Amendments to the Drawings:

Appl. No. 10/774,735
Amdt. dated July 26, 2005
Reply to O.A. of April 27, 2005

FIG. 4a.

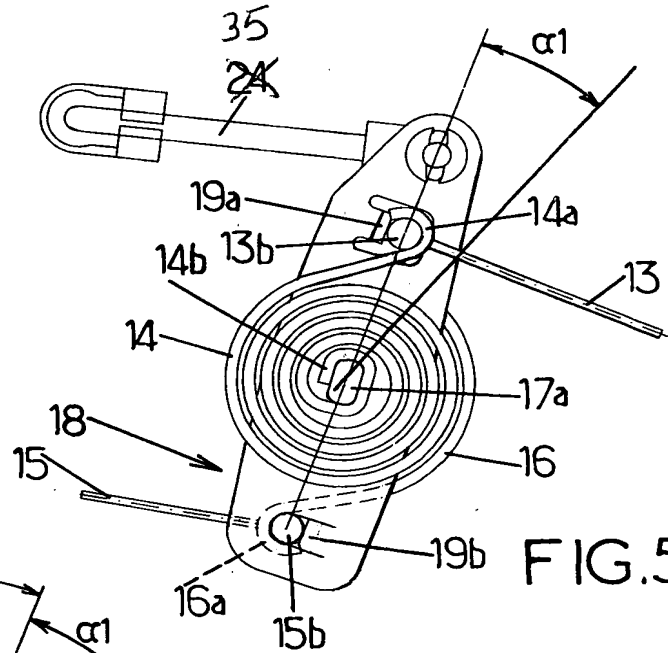
Element "24" has been changed to "35" on Figs. 4a, 4b, 5a, 5b, 6a and 6b.
